# Access Compliance Report

## Public Rights-of-Way

Intersection ID: 8315	Main Street: BRADFORD_DR	Cross Street: HOVIS_RD	Location: W
ADA ID: 1608C0DE995E	Ramp Type: Perp	Initial Pass/Fail: Fail	Overall Compliance: No
			Severity Score: 13.75

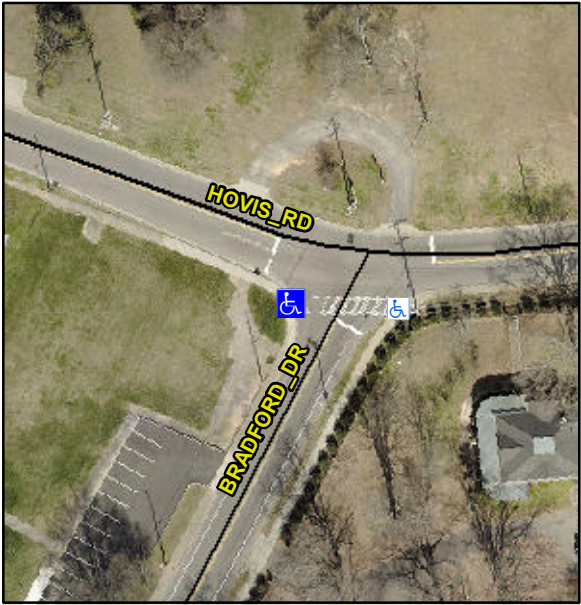
Codes/Mitigation Info/Possible Solution			Field Measurements/Component Compliance		
	Possible Solutions:		<b>Compliance</b>	<b>Description</b>	<b>Data</b>
	Remove & Replace Entire Ramp.		N/A	Ramp Length (in)	59.0
			Yes	Ramp Width (in)	48.0
			N/A	Flare Type LT	N/A
			N/A	Flare Slope LT (%)	N/A
			N/A	Flare Traversable LT?	N/A
			N/A	Landing Length (in)	N/A
			N/A	Landing Width (in)	N/A
			N/A	Landing Slope (%)	N/A
			N/A	Landing X Slope (%)	N/A
<p>Surveyor Notes:</p> <p>N/A</p> <p>PROW/ADA:</p> <p>R304.2.2, R304.5.3</p>			N/A	Flare Type RT	N/A
			N/A	Flare Slope RT (%)	N/A
			N/A	Flare Traversable RT?	N/A
			N/A	DWS Provided?	N/A
			N/A	DWS Contrast?	N/A
			N/A	DWS Length (in)	N/A
			N/A	DWS Full Width?	N/A
			N/A	DWS Offset (in)	N/A
			N/A	Gutter Ponding?	N/A
			N/A	Gutter Lip Ht (in)	N/A
<p>Total Cost:</p> <p>\$ 1850.00</p>			N/A	Painted X Walk1?	Yes
			N/A	X Walk 1 Direction	To E
			N/A	X Walk 1 Width (in)	90.0

N/A	X Walk 1 Slope (%)	9.6
			N/A	X Walk 1 X Slope (%)	3.4
			N/A	Ramp inside XWalk1?	Yes
			N/A	Road Slope (%)	N/A
			N/A	Road X Slope (%)	N/A
			N/A	Any Obstructions?	N/A
			N/A	Obstruction Type	
			N/A	Clear Space?	N/A
			N/A	Clear Space to XWalk (in)	N/A
			N/A	Storm Grate/Utility Hazard?	N/A
			N/A	Storm Grate/Utility Type	
			N/A		N/A
			Yes	Surface Condition? (G/P)	Good
